CITY OF OREGON CITY HISTORIC REVIEW BOARD AGENDA

GLUA-20-37 and HR 20-15: Historic Review for alterations to a contributing structure in the Canemah National Register District at 112 Miller St.

FILE NO.: GLUA-21-00037/ HR 21-00015: Historic Review

REQUEST: Historic Review for exterior alterations to a contributing home in the Canemah National Register District. This applications amends HR-21-00010 by substituting skylights for the approved shed dormer.

Sketch of proposed dormer.

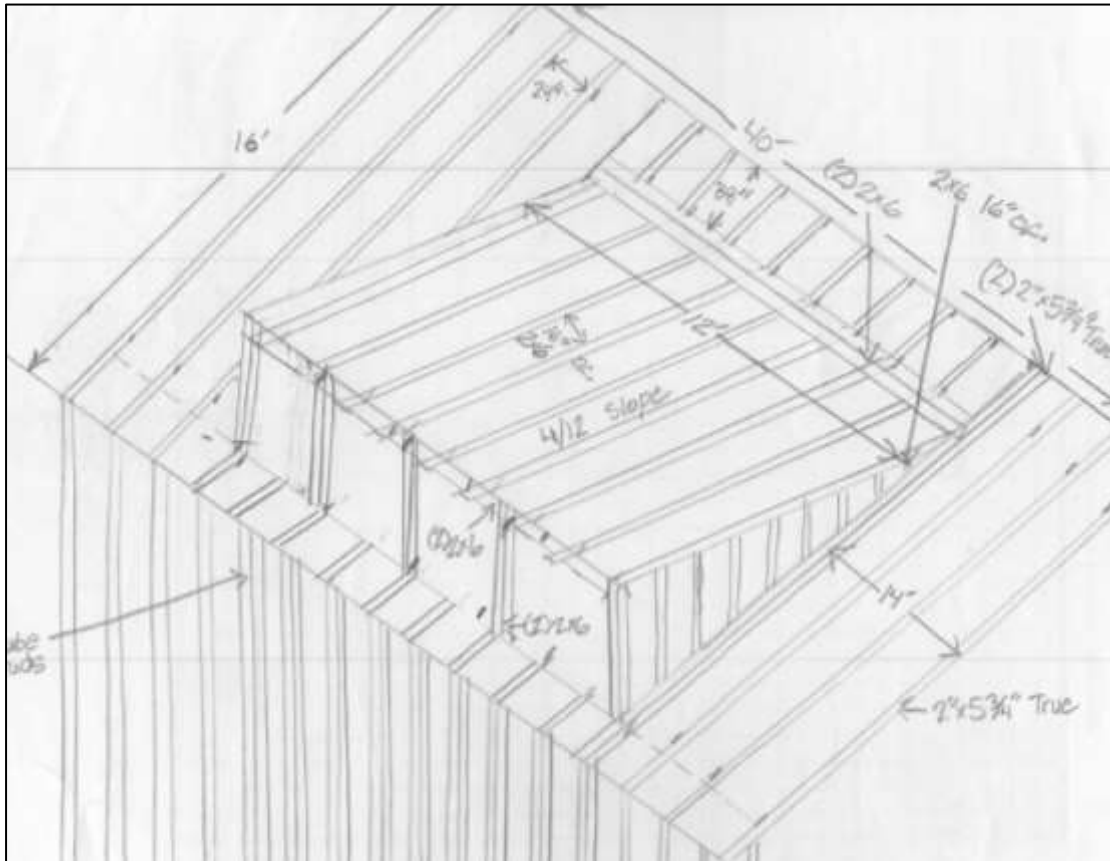
The applicant proposes to add a shed dormer on the north side of the home. While dormers are more typically on the front of a bungalow, the side dormer may be found to be appropriate. The applicant notes that upon a roof repair, evidence of a dormer was found on the north side of the roof, so it is possible that there was a dormer there in the past, although no historic photos are available. Shed dormers are common on bungalows, and gable dormers are sometimes used as well. The roof slope is

likely a 6:12 on the main house. The proposed dormer has a 4:12 slope and is placed centrally along the 40-foot side of the home, which will provide balance. The size of the dormer is 12 feet wide, compared to a roof plane of 36 to 40 feet in length; it is proportionally sized. It is proposed to be setback from the front edge of the roofline is 16 feet, which will also reduce the impact of its appearance. The proposed four windows of 2:1 proportion in the dormer are also appropriately sized.

The applicant shall ensure that the dormer trim, eaves, and brackets on the dormer match that of the rest of the house. The face of the dormer shall be set back from the existing wall to provide balance in design.
